**ADDENDUM NO. 2  
TO CONTRACT DOCUMENT PLANS SPECIFICATIONS**

**PROJECT: MWA METRO PARK EAST LANDFILL  
P-65 CELL F LINER CONSTRUCTION**  
**TO: PROSPECTIVE BIDDERS AND OTHER INTERESTED PARTIES**

METRO PARK EAST  
MWA PROJECT P-65  
PHASE II CELL F LINER CONSTRUCTION

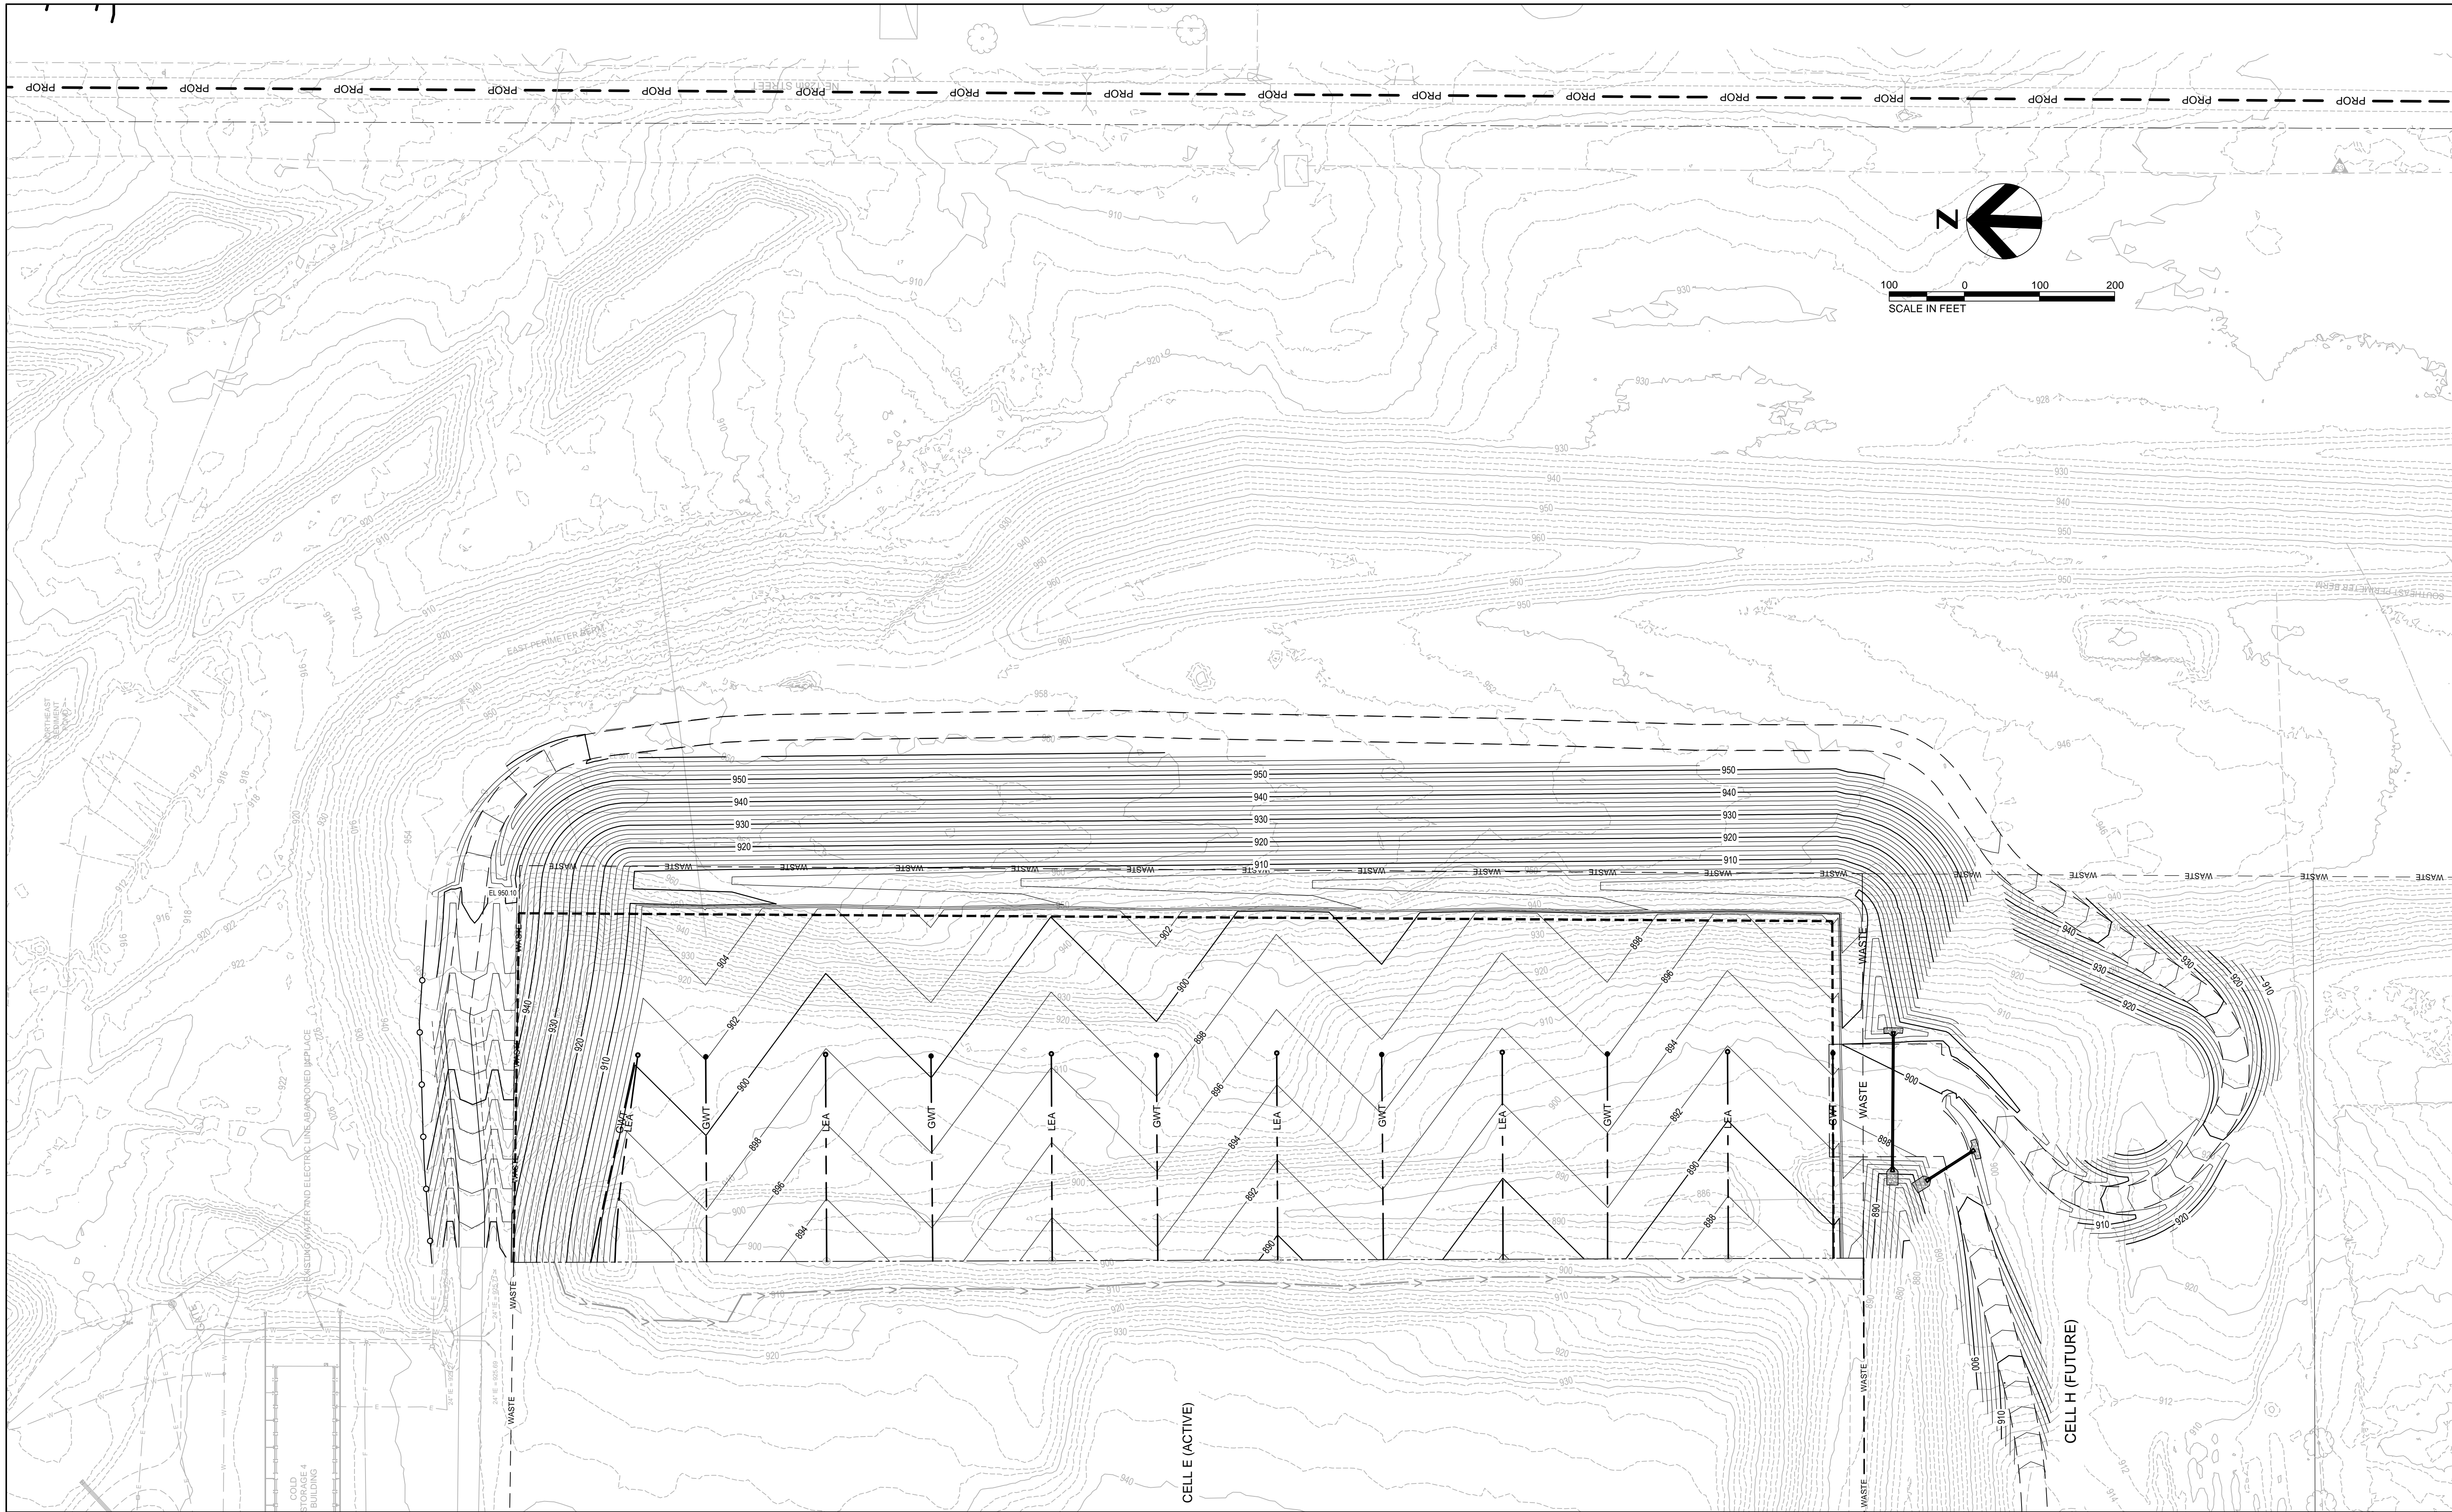
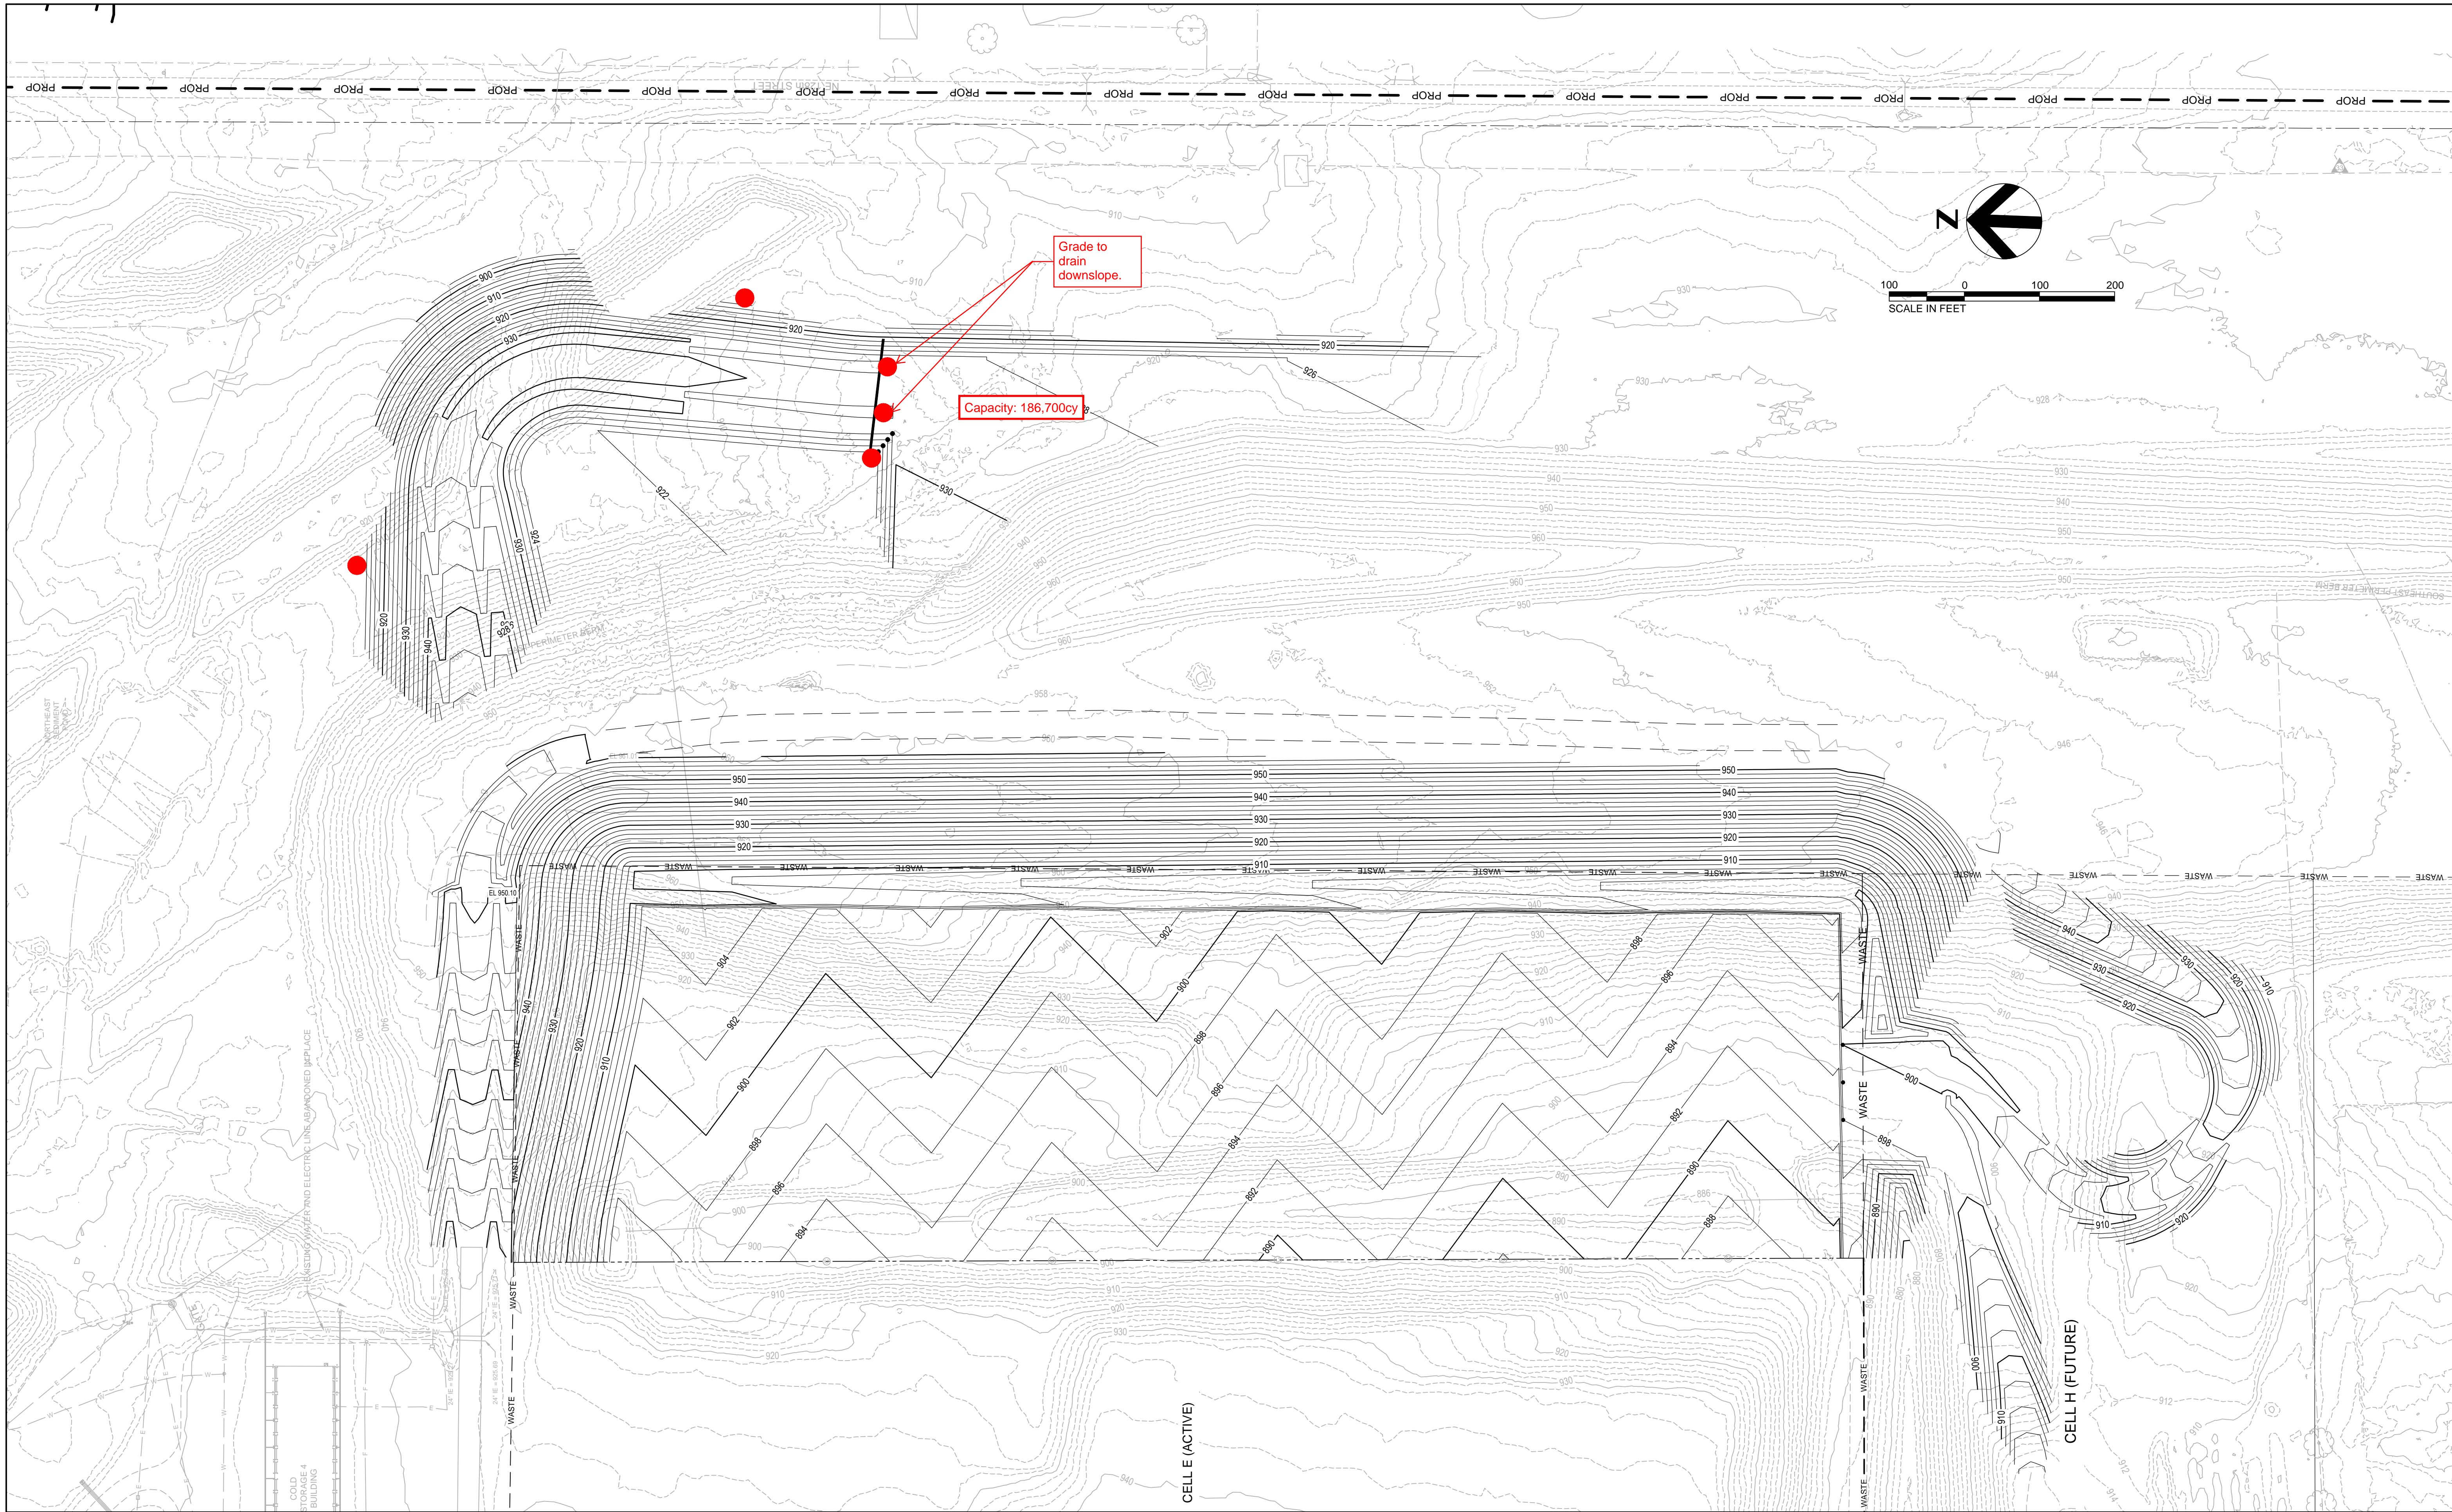
- A. Within Section 01 29 01 include the following changes:
  - a. Add to Bid Item 106: Incidental to this item is the 24-inch diameter CMP temporary culvert shown on the attached figure. 160-LF of culvert to be placed with this item.
  - b. ADD: ALTERNATE Bid Item 122: Excavate, load, and haul soils from the Project Area to South Berm stockpile area
    - i. Measurement shall be by the cubic yard volume of soil excavated from the expanded Cell F project area and placed at the south berm stockpile area. Incidental to this item is temporary stockpiling, fine grading of stockpile and excavation area, promoting positive drainage, and segregation of material type. Incidental to this item is clearing and grubbing and stripping vegetation and topsoil from the stockpile area and grading into a stockpile prior to stockpiling additional material in the area.

*Question 24: What is the proposed haul route to the southwest stockpile area?*

Answer 24: See attached figure.
